01	ISSUED FOR ADDENDUM-1	11/05/12	AL
00	ISSUED FOR TENDER	11/05/03	AL
NO.	REVISIONS	Y/M/MDD	BY

BID OPPORTUNITY NO. 377-2011

**DEACON BOOSTER PUMPING STATION BLDG UPGRADES & MAINTENANCE**

DEMOLITION PLAN

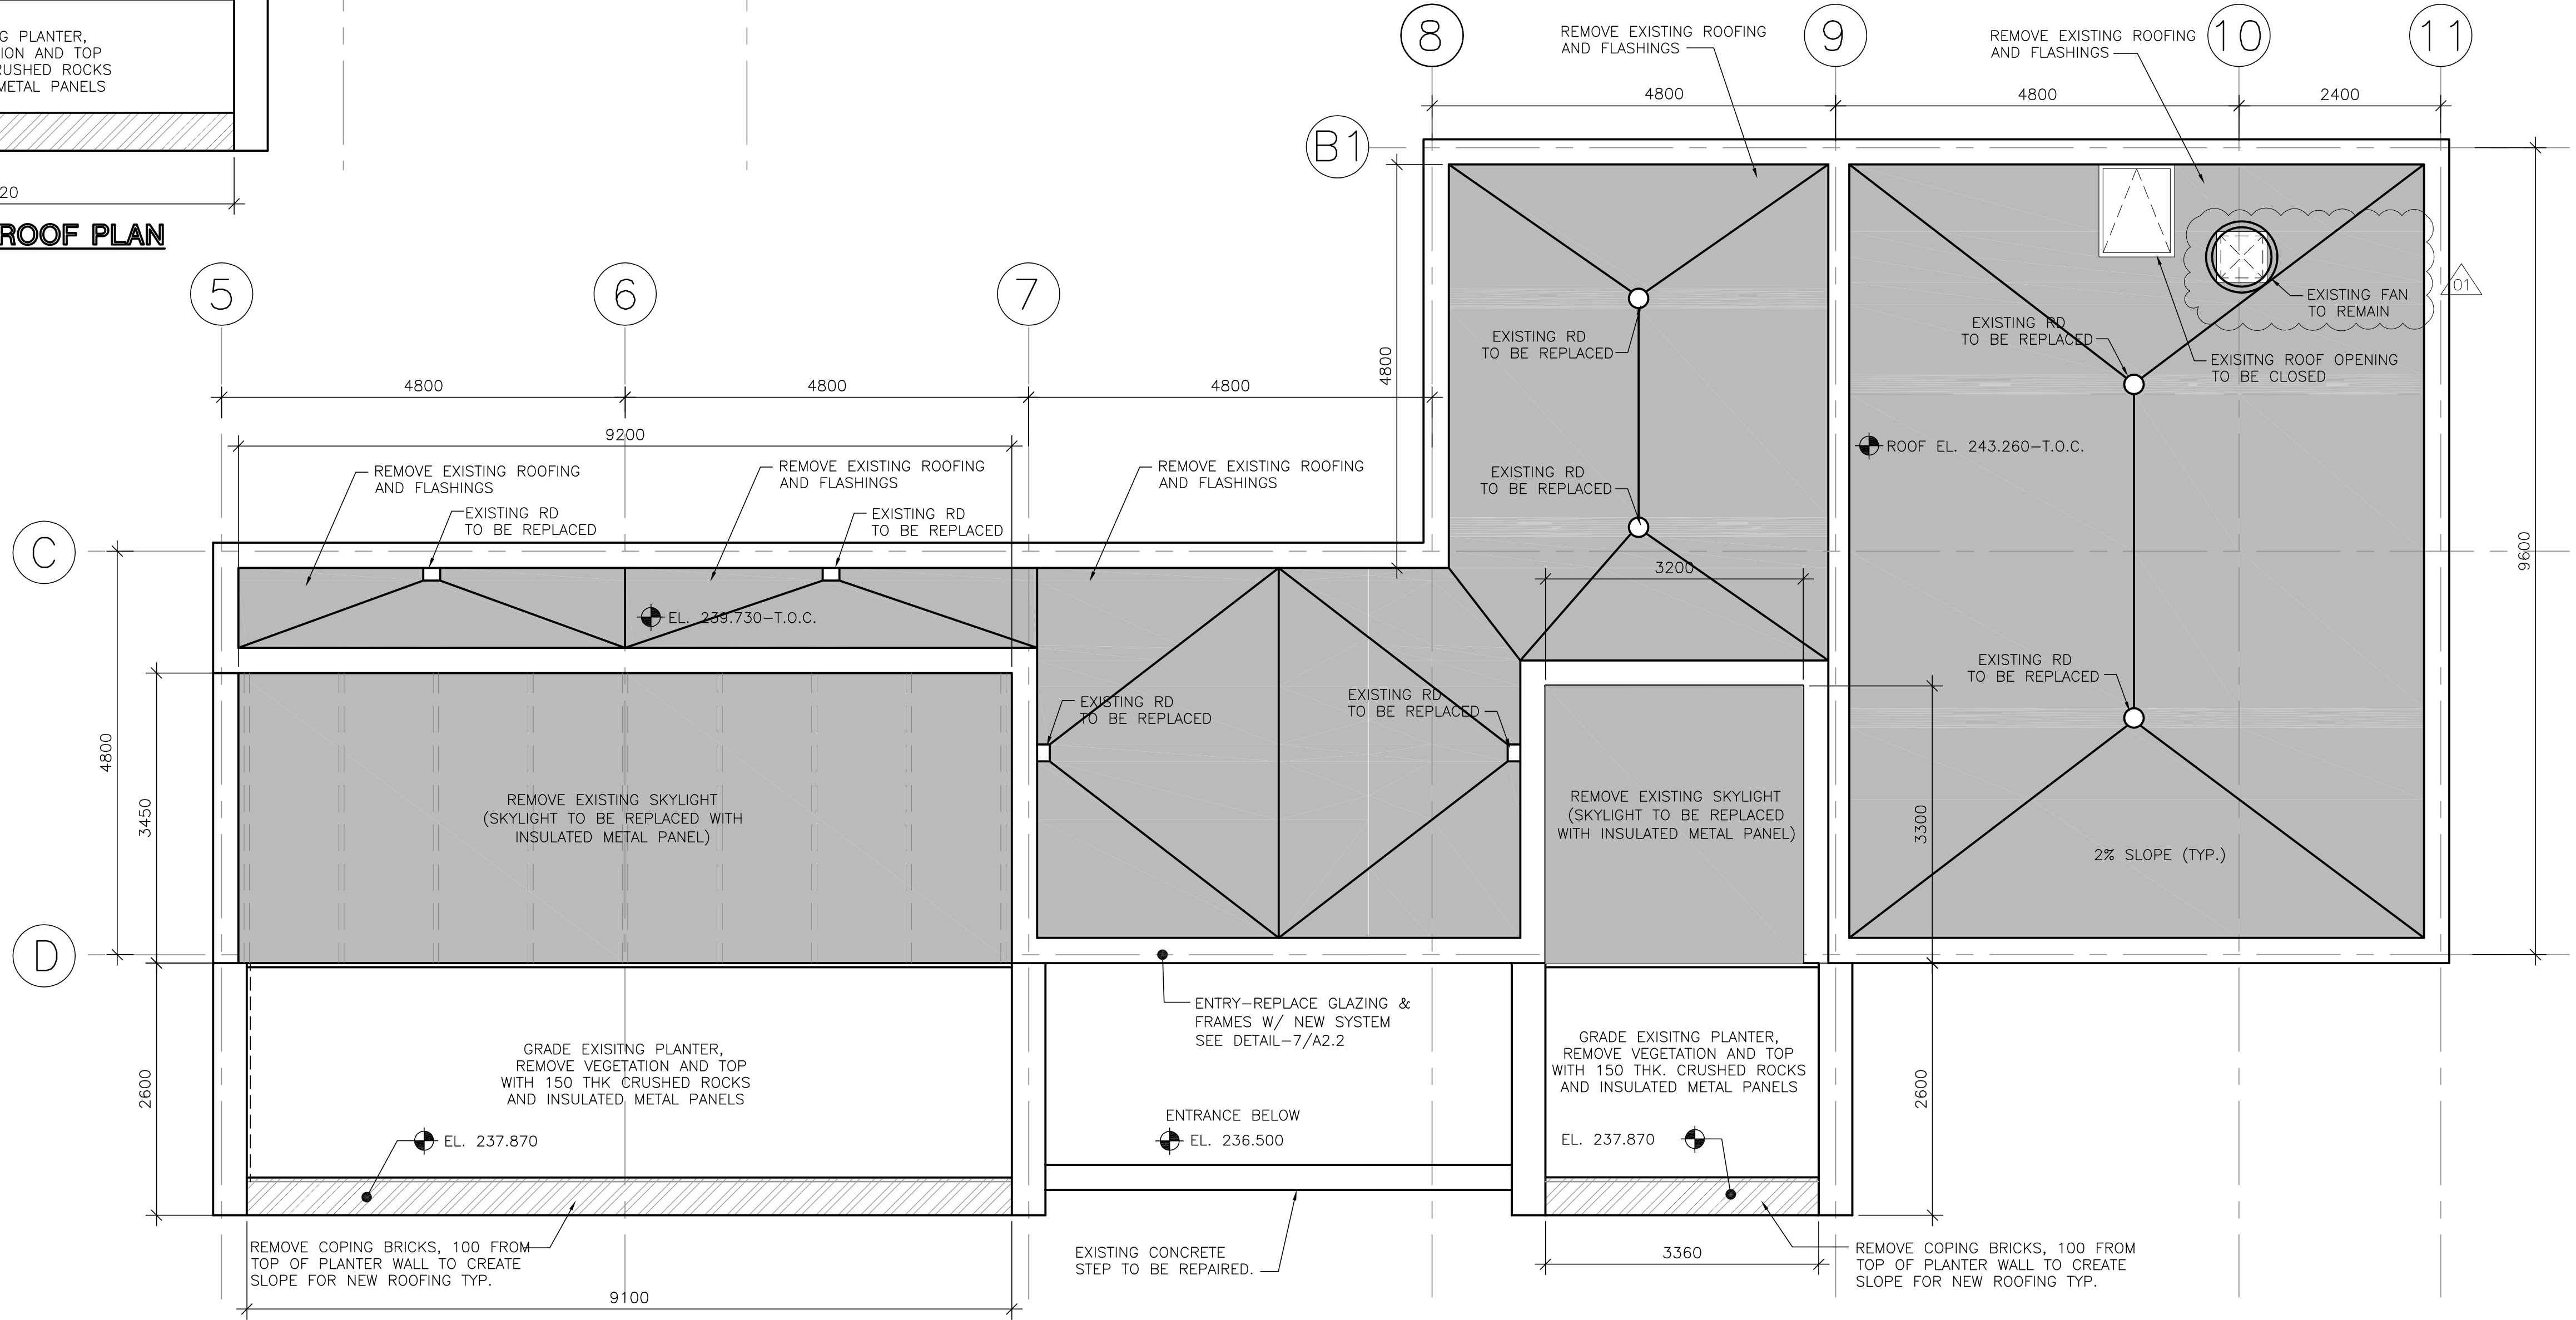
REMOVE COPING BRICKS, 100 FROM TOP OF PLANTER WALL TO CREATE SLOPE FOR NEW ROOFING TYP.
